ONTARIO ENERGY BOARD

AND IN THE MATTER OF an application by Enbridge Gas Inc. pursuant to Condition 4 from the Ontario Energy Board's Decision and Order dated April 1, 2020, and Section 101 of the *Ontario Energy Board Act, 1998* for authority to construct a work upon, under or over a highway, utility line or ditch in the County of Essex for the purposes of a natural gas pipeline in respect of which the Ontario Energy Board granted leave to construct in EB-2019-0172 to Enbridge Gas Inc.;

**INTERROGATORIES TO THE CORPORATION OF THE COUNTY OF ESSEX
("County of Essex") FROM ENBRIDGE GAS INC. ("Enbridge")**

FIGURE 4 – Minimum Cover DEPTH for Underground Installations

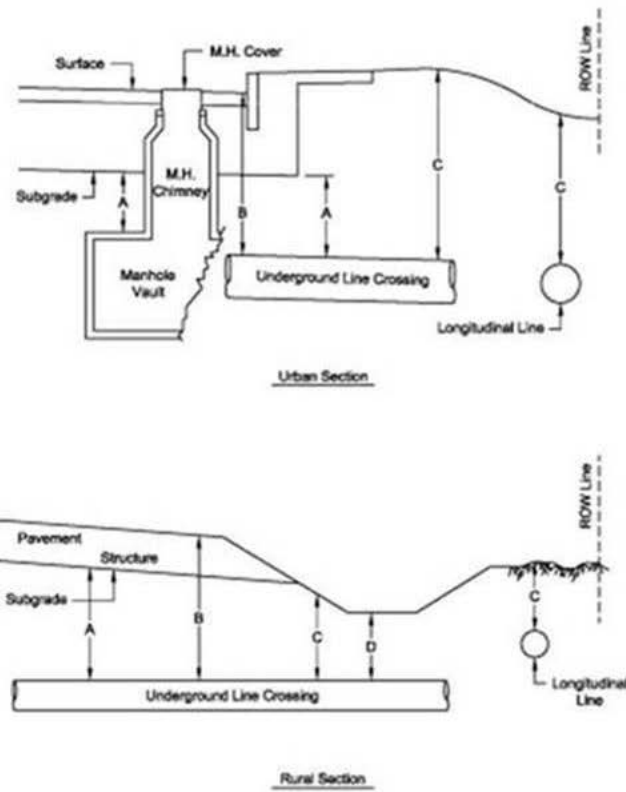
- c) Does Figure 4, Table 1, and Column C of the *Guidelines for Underground Utility Installations Crossing Highway Rights-of-Way* indicate that the depth of cover for longitudinal pipelines is 1.0 m?

Thanks for reaching out to us regarding the application of this document. As discussed you assessment listed below regarding the intent of the document is correct. I have attached a copy for everyone's reference. Look particularly at the Figure 4, which I have also cut and pasted to the bottom of this e-mail for ease.

Gentlemen. It appears as though Essex County is using our document and may be misinterpreting the content relative to this situation. I know when written it was intended, as per the title, to be relevant for crossings and not parallel lines. Figure 4 may however open the door to this misinterpretation.
